TECHNICAL NOTE

PROJECT: Land adjacent Woodgate Nurseries, Lidsey Road, Woodgate

PLANNING REFERENCE: AL/129/21/OUT

REPORT: 2087/TN/04 – Response to highway officer comments dated 30th November 2021

Proposed Site Access Arrangement (HTp/2087/36)

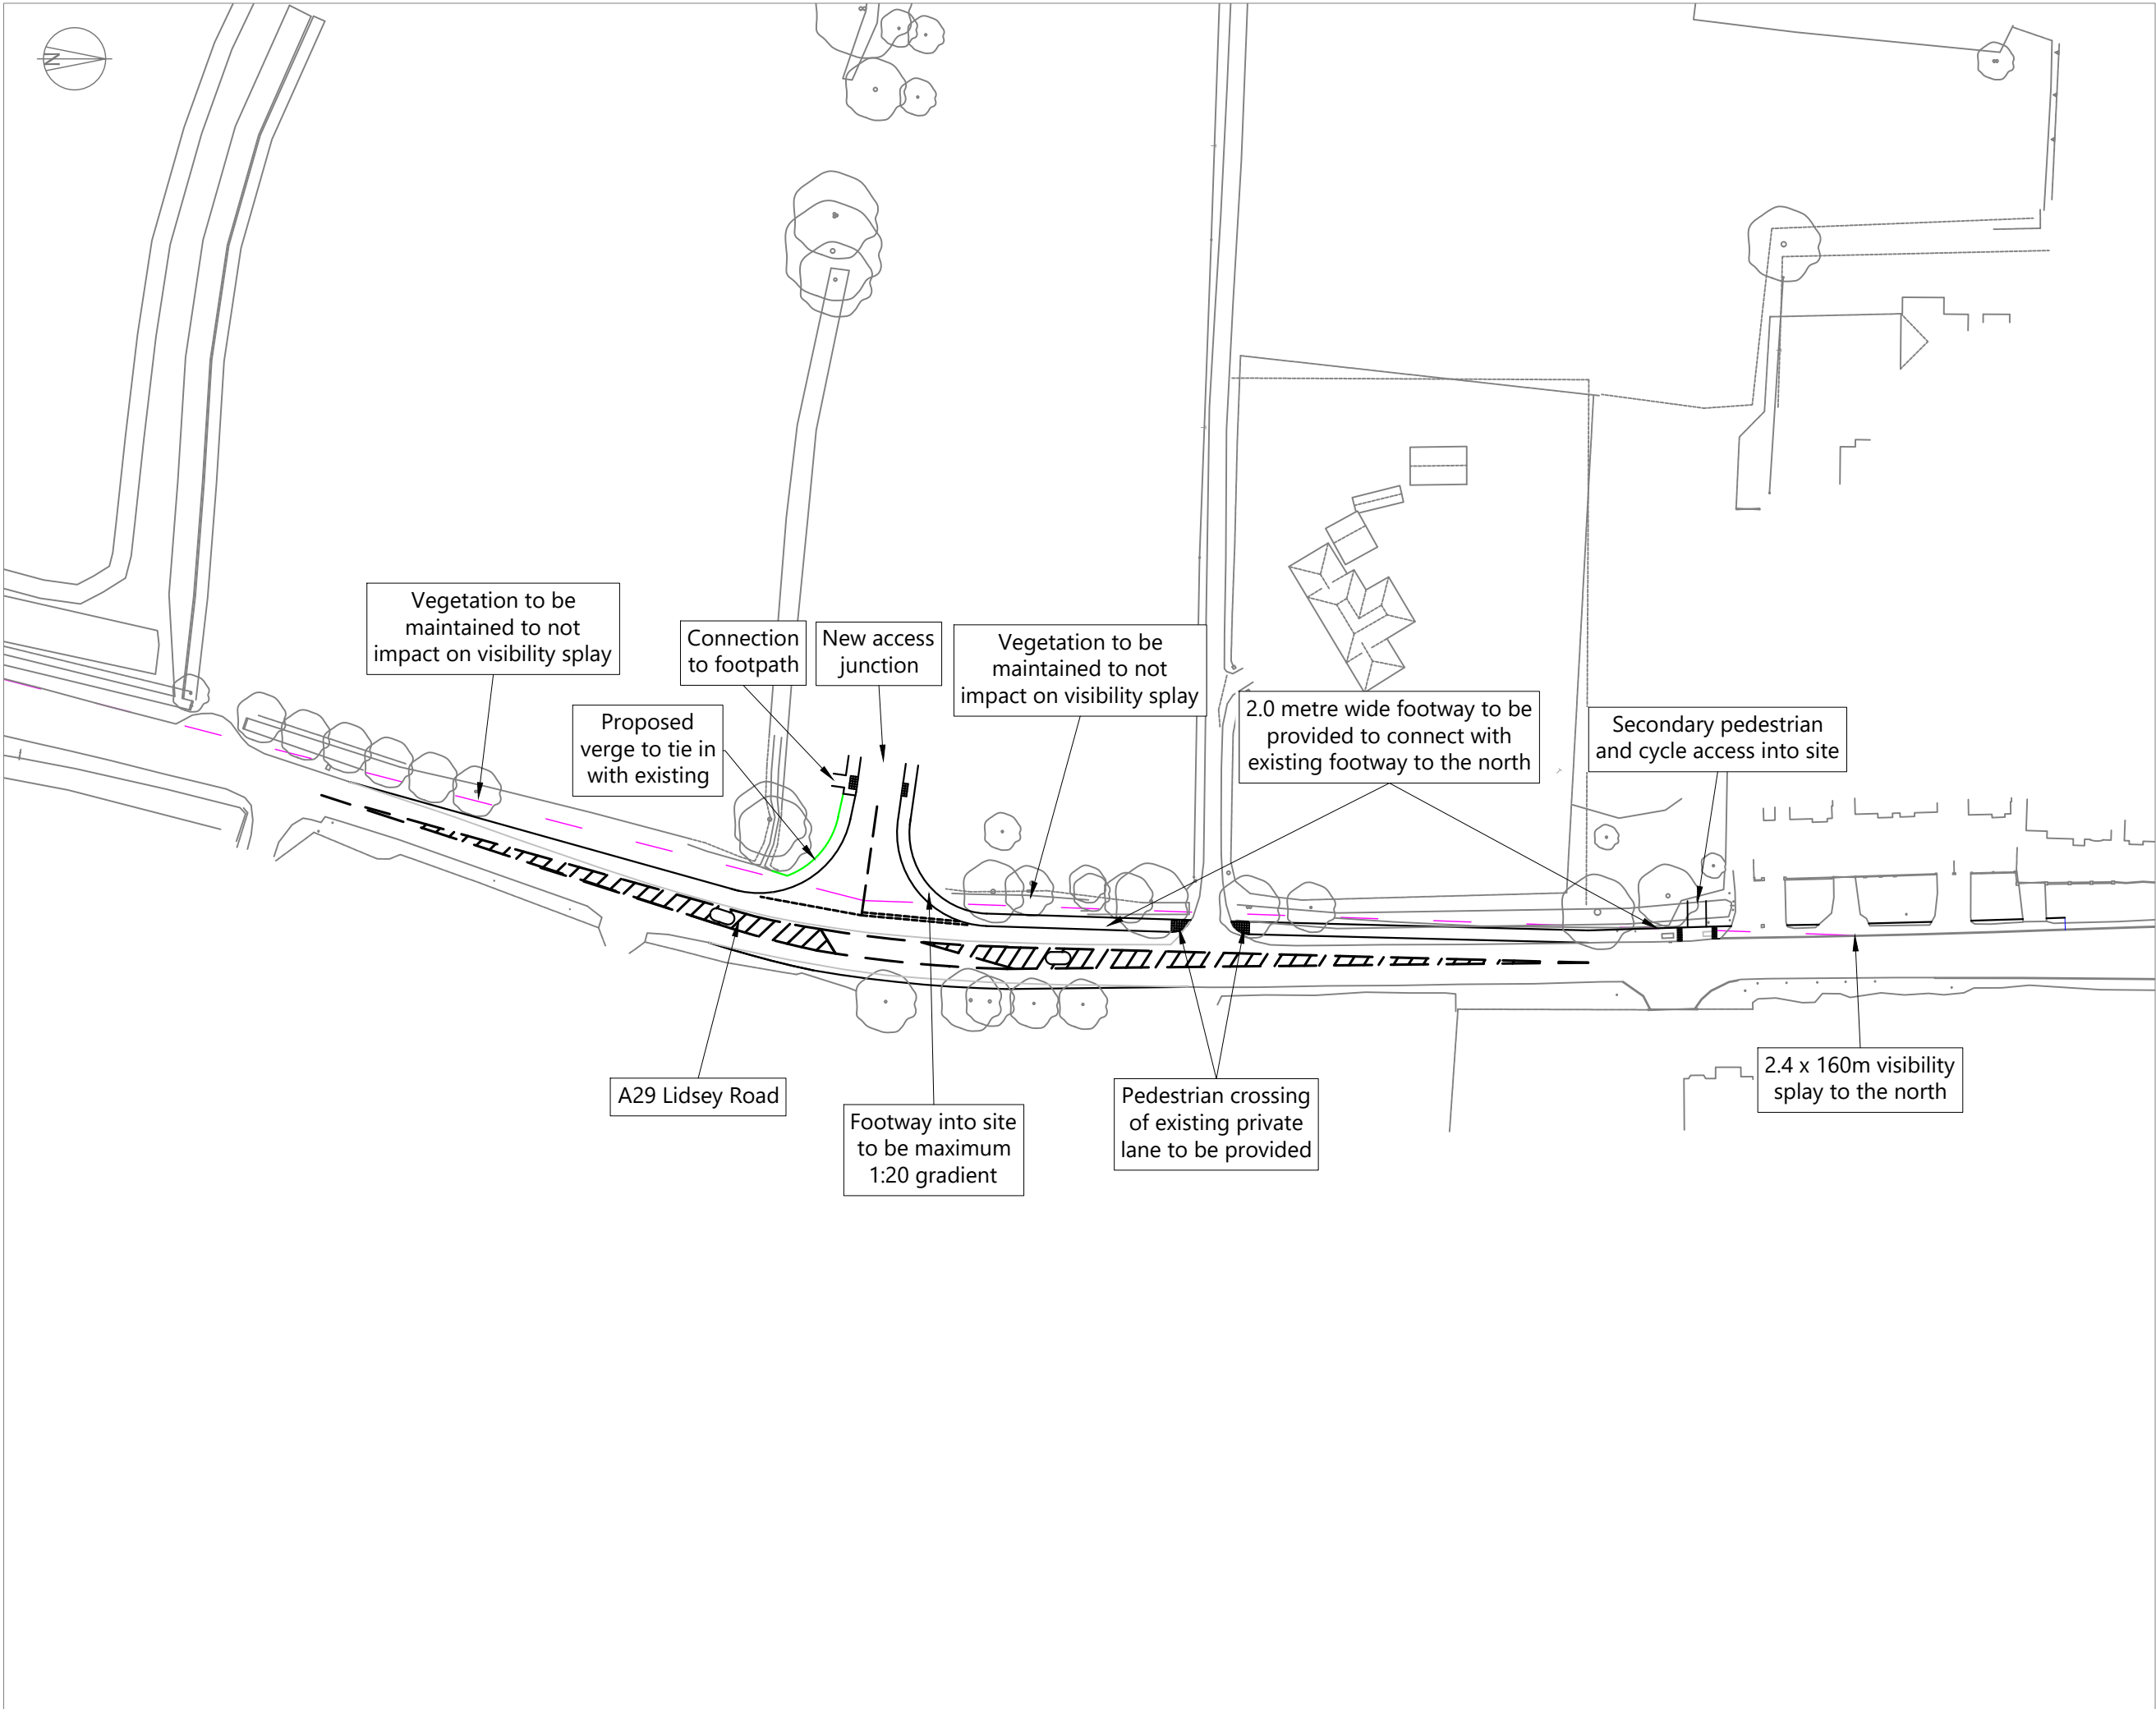
- iv. Agreement that the details of temporary and/or permanent warning signage can be determined as part of the S278 process.
 - v. The proposed site access plan should be modified to include:

- The path in north eastern corner of the site should be widened to allow for cycle access in addition to pedestrian access.
 - The footway along Lidsey Road to the north of the site should be widened to 2.0 metres up to where it meets the highway improvements associated with the Wing's Nursery development (AL/32/19/OUT).

4. In respect of **paragraph 3.v.**, the proposed site access plan has been modified slightly as a result of the design check requested in the consultation response and this is shown on drawing HTp/2087/36 (provided at **Appendix 2**). The modifications comprise:

- i. The path between the north eastern corner of the site and Lidsey Road has been widened to 3.0 metres to allow for access by cyclists in addition to pedestrians.

- ii. This modified path is complimented by a dropped kerb to allow access to and from Lidsey Road with ladder paving to warn pedestrians walking along Lidsey Road that cyclists may be crossing.

- iii. The footway along Lidsey Road to the north of the site being widened to 2.0 metres to the southern extents of the highway works area associated with the Wing's Nursery development.

- iv. For the avoidance of doubt the proposed widening will utilise land currently forming the highway verge and no modifications will be made to the existing private accesses.

- v. At the site access junction, minor modifications to the southern kerb line of the site access, the location of traffic islands and road markings.

Overlay Plan of the BEW Consortium Roundabout and Site Access Proposals

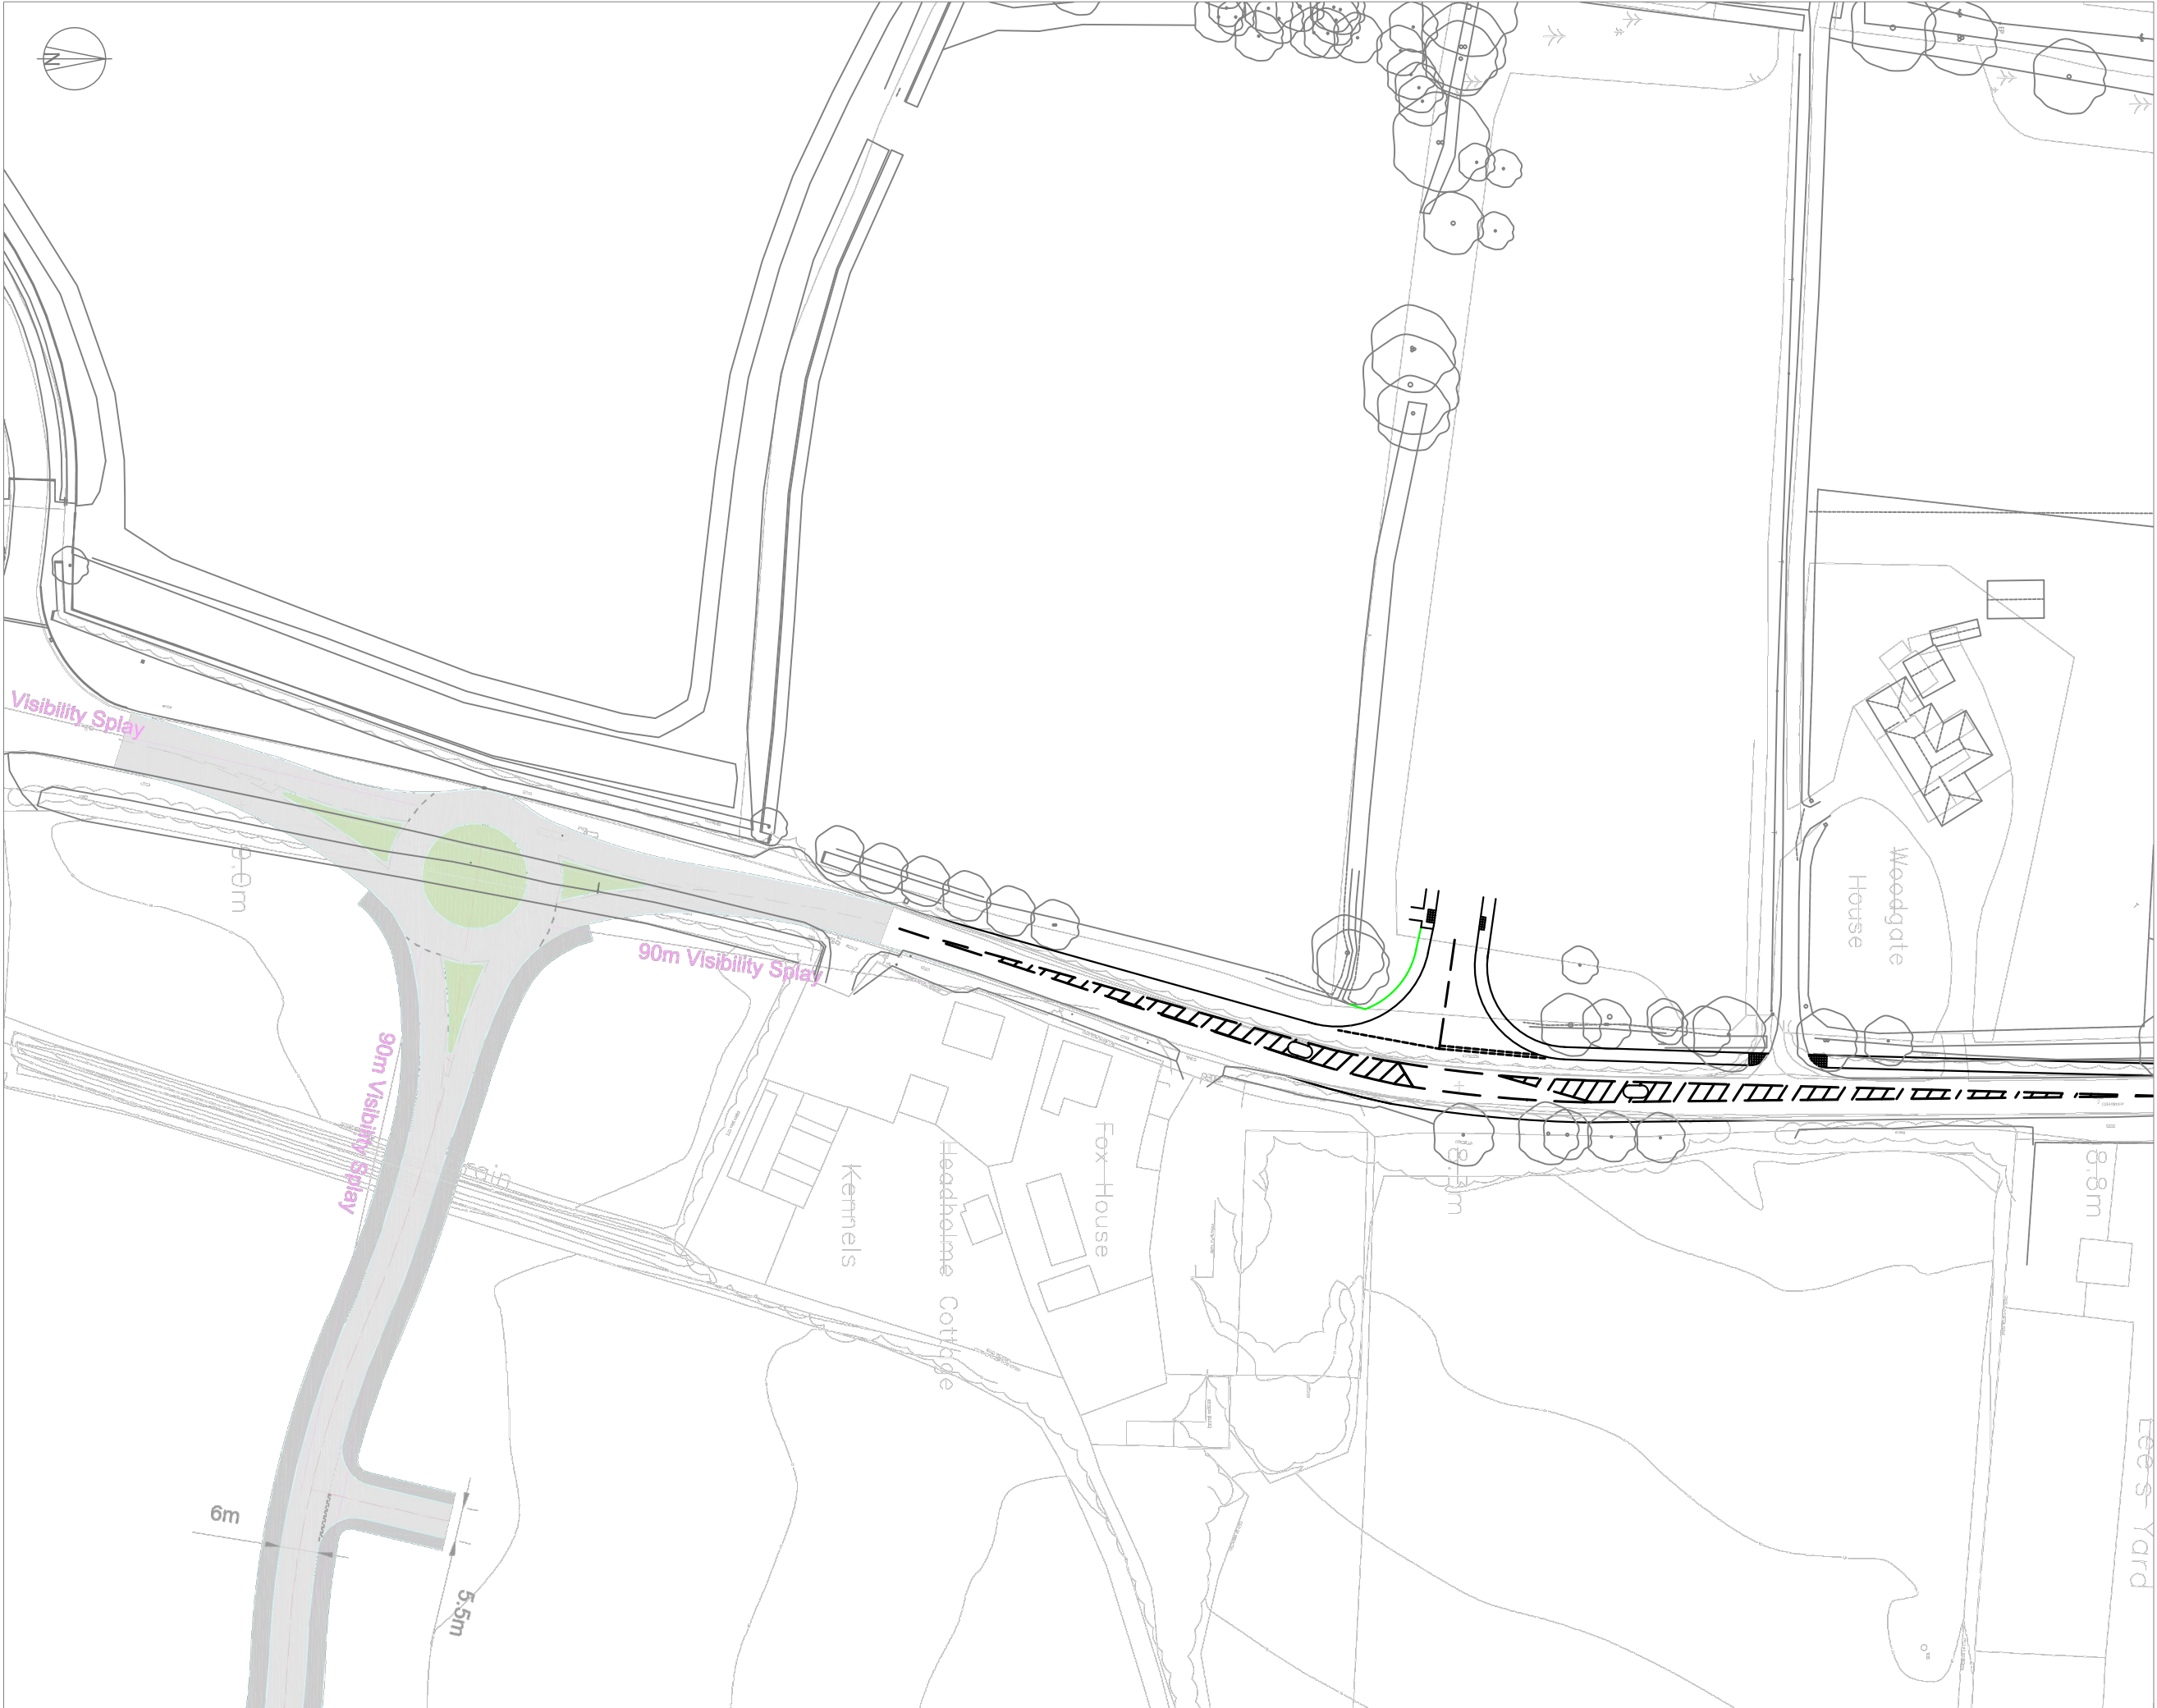
- vi. An overlay plan should be provided which shows the BEW roundabout and the proposed site access to confirm that the access proposals do not hinder the deliverability of the BEW roundabout.

6. A plan (HTp/2087/35/A) showing the BEW Consortium masterplan road layout overlain on the access proposals is provided at **Appendix 2**.
7. From this it can be seen that the access proposals are compatible with the BEW roundabout proposals.
